**COUNTY OF SAN MATEO
PLANNING AND BUILDING DEPARTMENT**

SUBJECT: EXECUTIVE SUMMARY: Consideration of an appeal of the Coastside Design Review Committee's decision to approve a Design Review Permit and Grading Permit pursuant to Section 6565.3 of the County Zoning Regulations and Section 9283 of the County Ordinance Code, for the construction of a new 2,771 sq. ft. two-story single-family residence, with an attached 507 sq. ft. two car garage, 330 cubic yards of grading and no tree removal, on a vacant 5,230 sq. ft. parcel, located between 631 and 647 El Granada Boulevard , in the unincorporated El Granada area of San Mateo County.

County File Number: PLN 2019-00162 (Love/Zheng)

SUBJECT: Consideration of an appeal of the Community Development Director's decision to approve a Design Review Permit and Grading Permit, pursuant to Section 6565.3 of the County Zoning Regulations and Section 9283 of the County Ordinance Code, for the construction of a new 2,771 sq. ft. two-story single-family residence, including an attached 507 sq. ft. two-car garage, 330 cubic yards of grading and no tree removal, on a vacant 5,230 sq. ft. parcel, located between 631 and 647 El Granada Boulevard, in

Figure 3 - Steep brush covered slope below proposed house

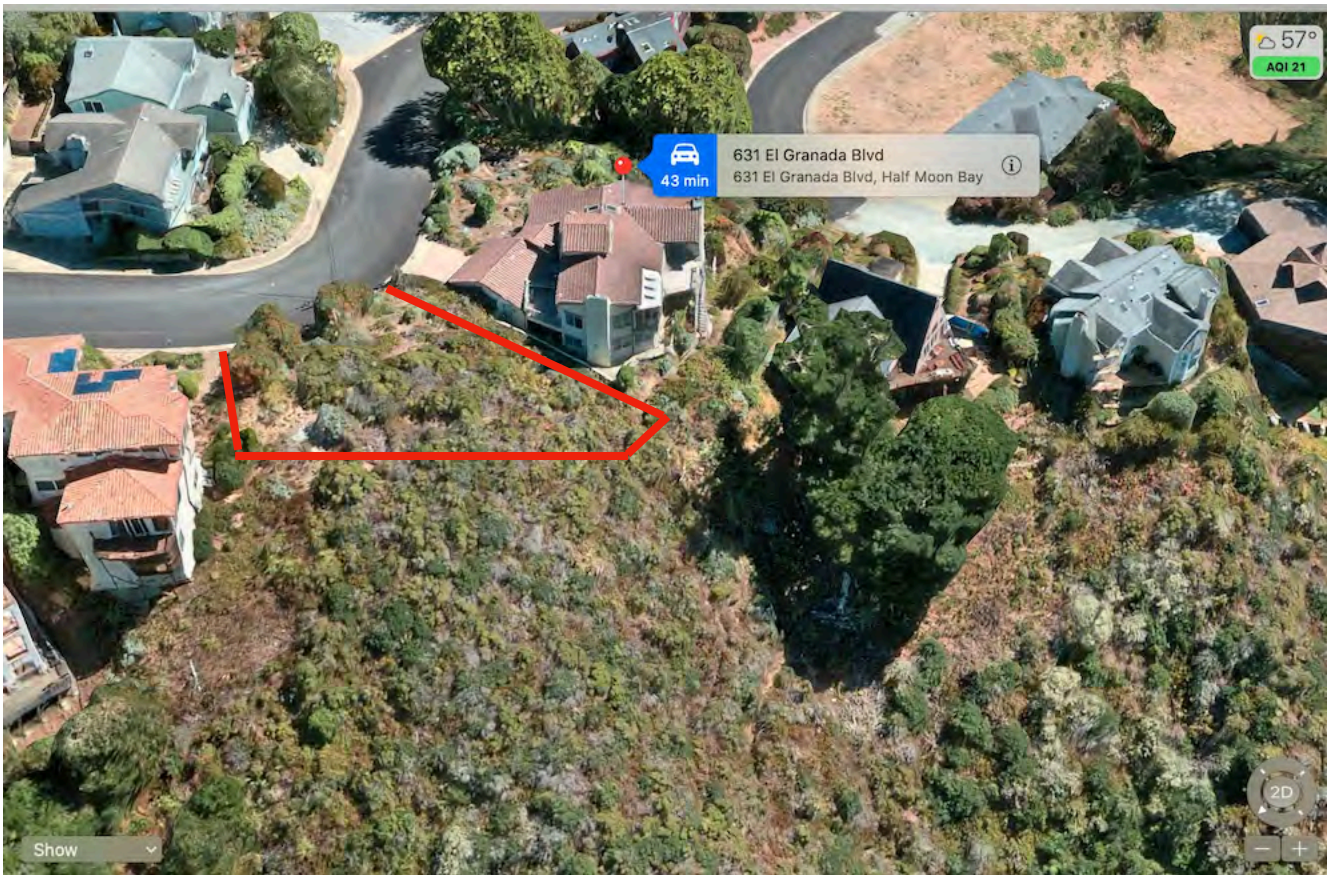
Because the ground slope becomes much steeper on the adjacent parcel [see Figure 3 below], ***the concentrated runoff will increase in speed and turbulence and cause more erosion. The gully will continue to enlarge and eventually extend the erosion onto multiple adjacent and nearby properties with significant loss of land.***

Because the ground slope becomes much steeper on the adjacent parcel [see Figure 3 below], the concentrated runoff will increase in speed and turbulence and cause more erosion. The gully will continue to enlarge and eventually extend the erosion onto multiple adjacent and nearby properties with significant loss of land.

1 DD - Site Plan
1/8" = 1'-0"

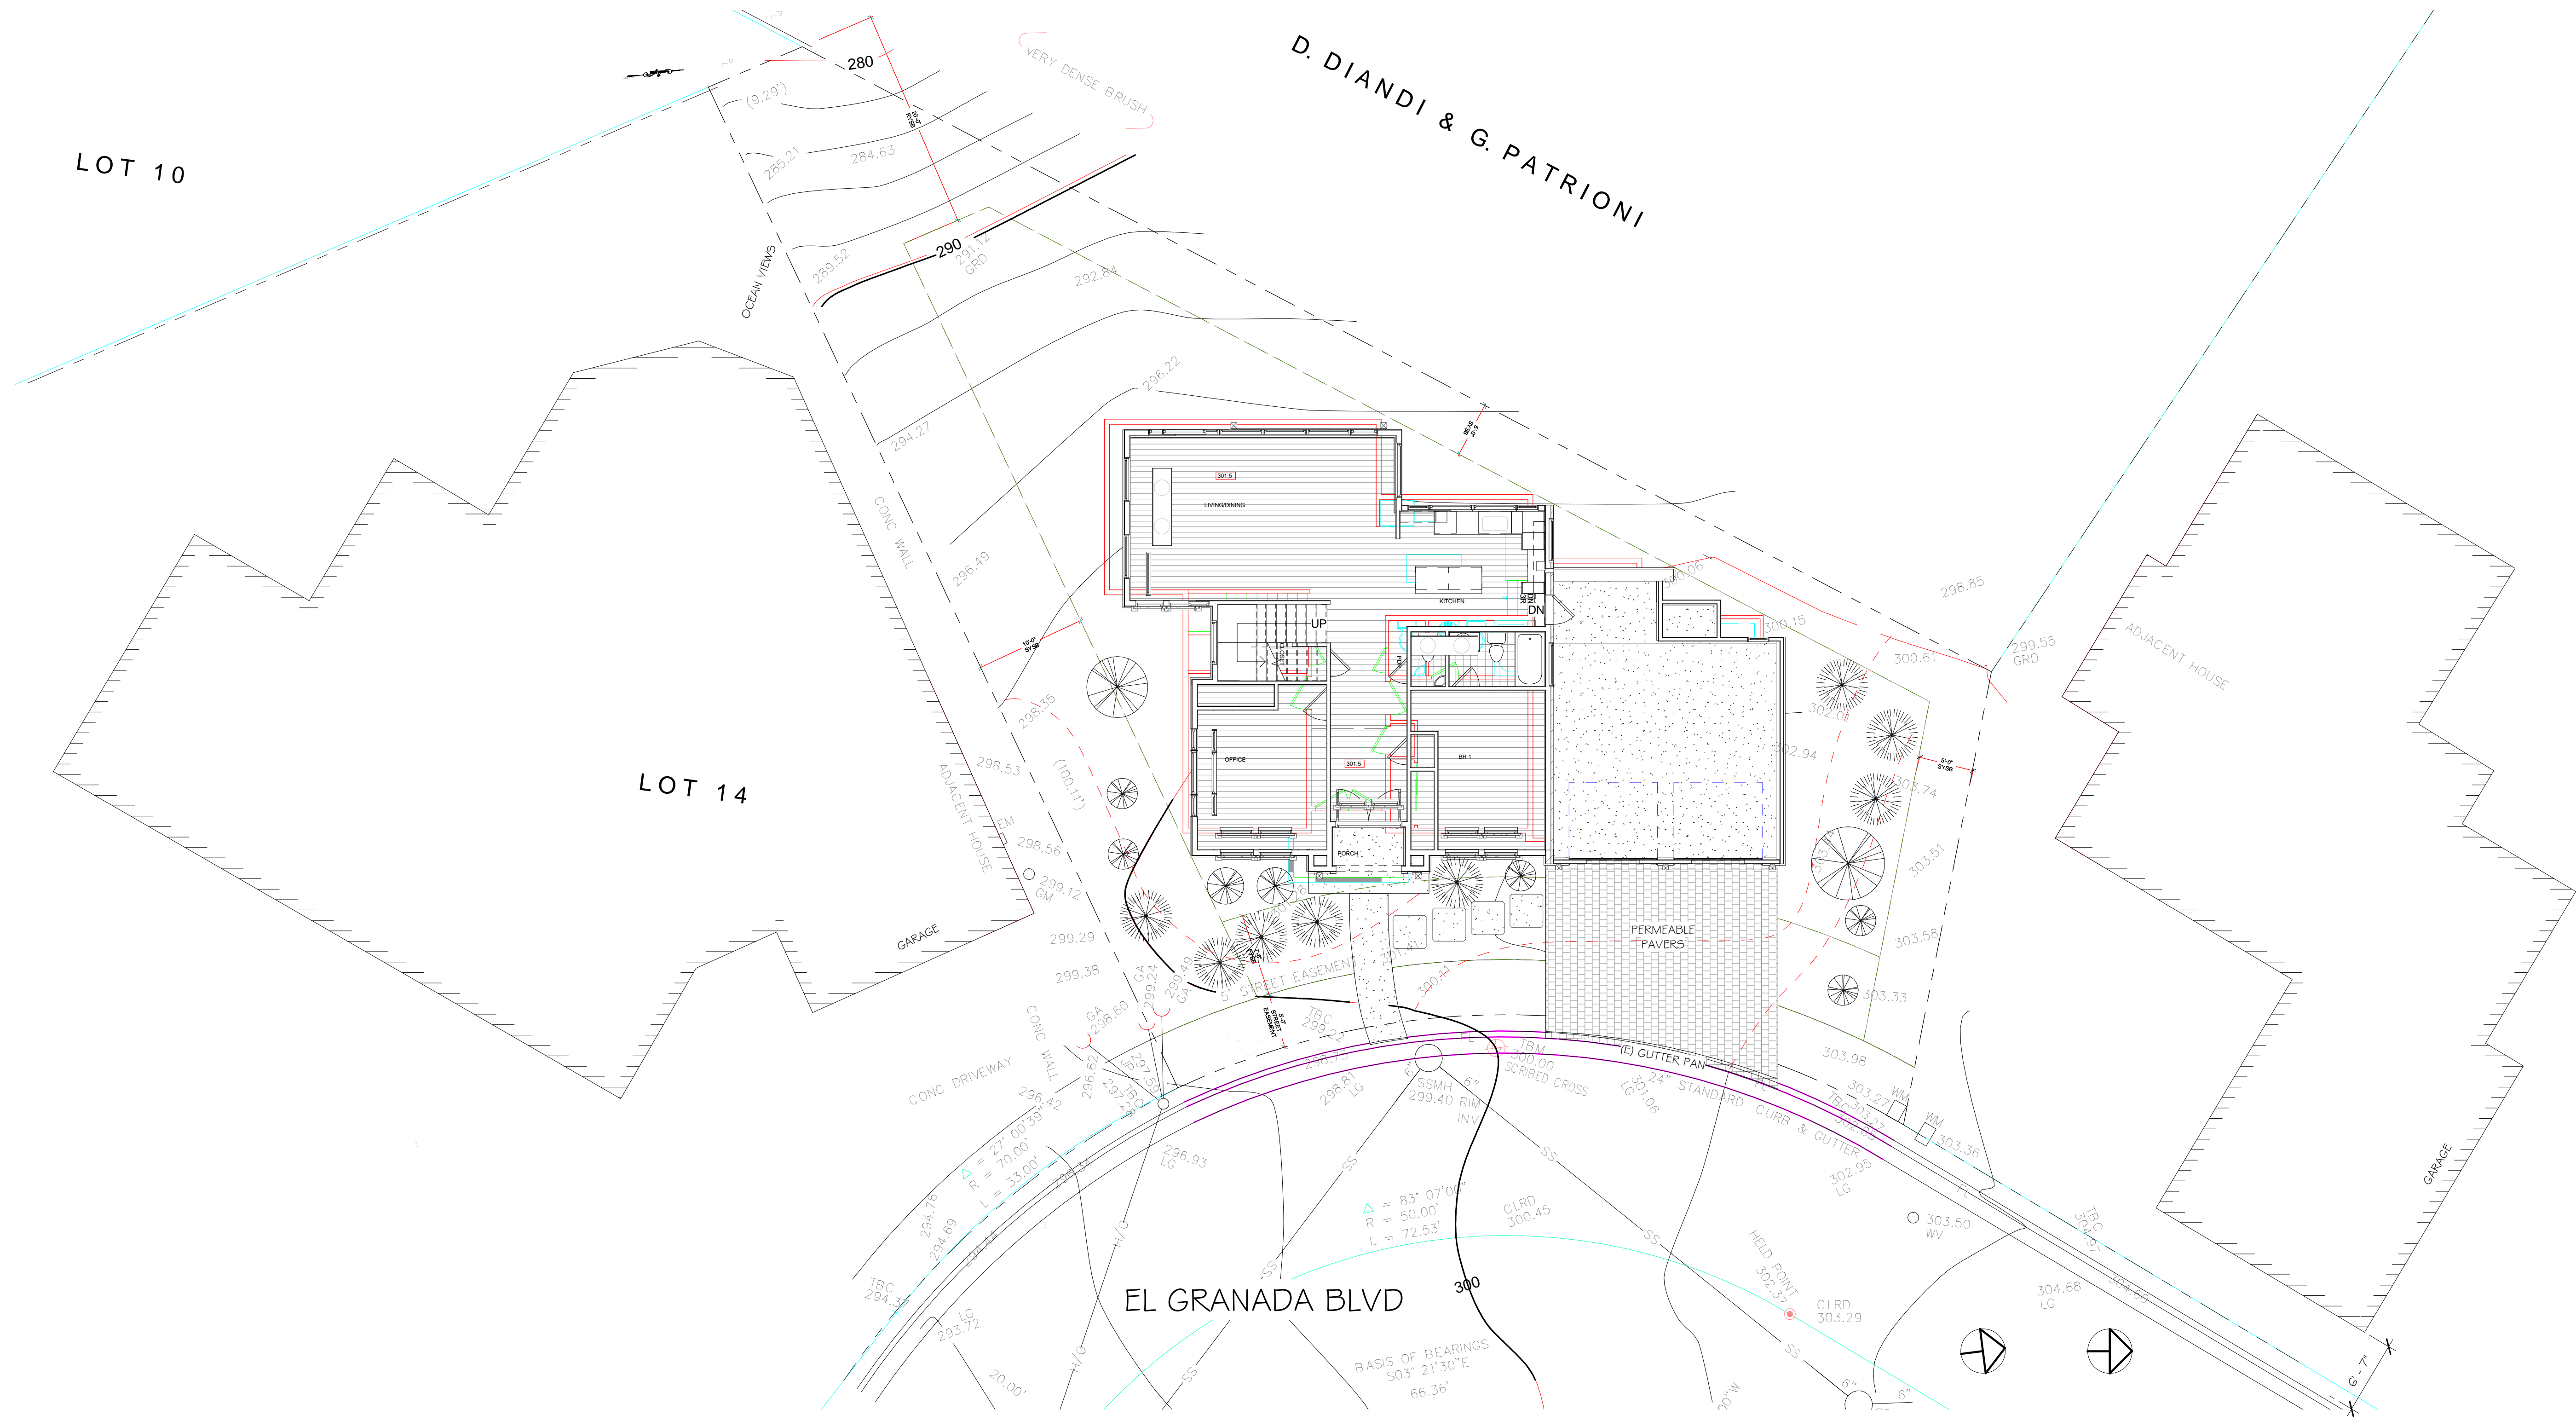
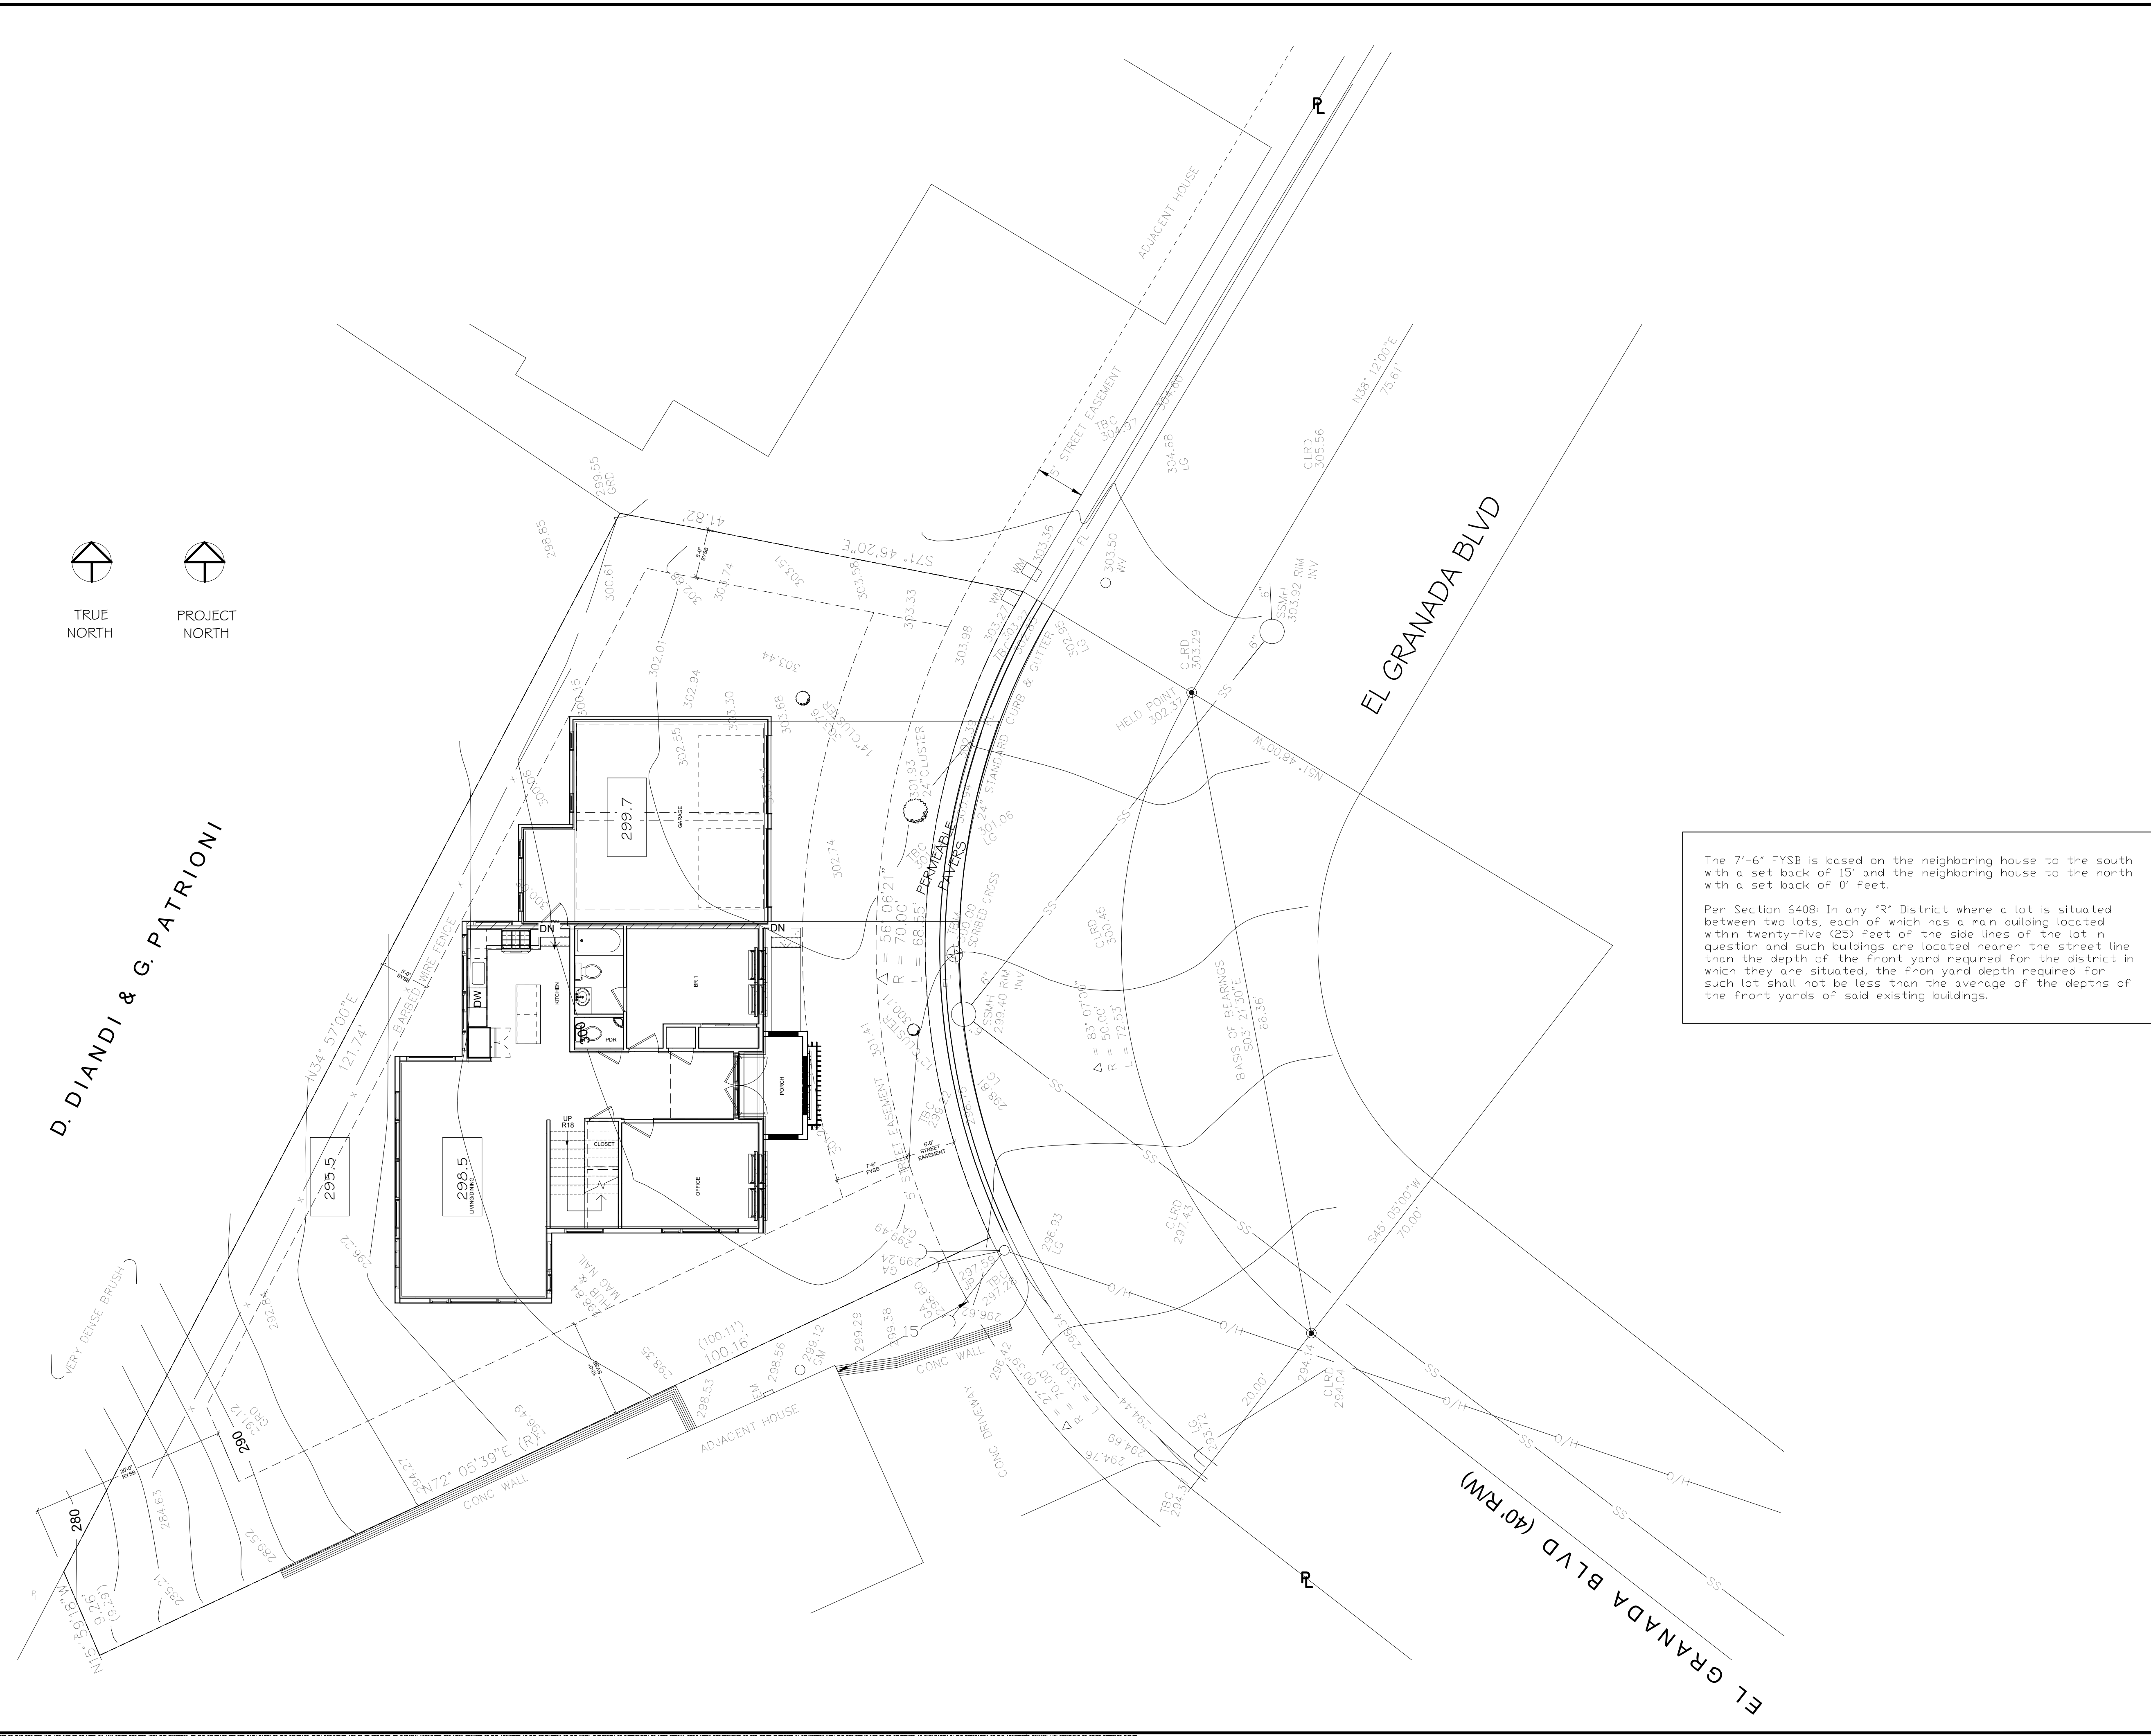
The roof of the proposed residence exceeds the setback by nearly half a foot on the southwestern property line adjacent to my house (*i.e.*, the roof above “Bedroom 3” as shown on Sheets A0.02, A1.02, and A1.03 of Mr. Zheng’s March 2020 plans). This not only exceeds my disputed easement, but also exceeds the standard lot setback requirement. The following highlighted portion of Sheet A0.02 illustrates the problem:

The roof of the proposed residence exceeds the setback by nearly half a foot on the southwestern property line adjacent to my house (i.e., the roof above "Bedroom 3" as shown on Sheets A0.02, A1.02, and A1.03 of Mr. Zheng's March 2020 plans). This not only exceeds my disputed easement, but also exceeds the standard lot setback requirement.

As a result, the “Office” roofline crosses the required 10-foot setback from the southside property line (my house) by nearly 4 feet. This expansion is shown on Sheets A0.02 and A1.03 of the revised plans. This unnecessary expansion encroaches upon my property, further impedes neighbors’ street level views, and does not provide sufficient spacing between houses. Here’s a highlighted version of Sheet A0.02 showing how the house extends over the setback, which is marked in yellow and the house in red:

Staff Response: Roof eaves of up to two feet in depth are allowed to encroach into setbacks. The original roof eave in this location was designed properly with the standard 2 feet depth. However due to the angle/position of the roof eave in relation to the left side yard setback, the standard two feet deep eave encroached into the left side yard setback 2 ft. 6 inches where the permitted encroachment is 2 ft. Staff requested that the applicant to redesign the roof eave, and the applicant has done so such that the roof eave no longer encroaches into the left side yard setback, beyond the 2 ft. normally permitted.
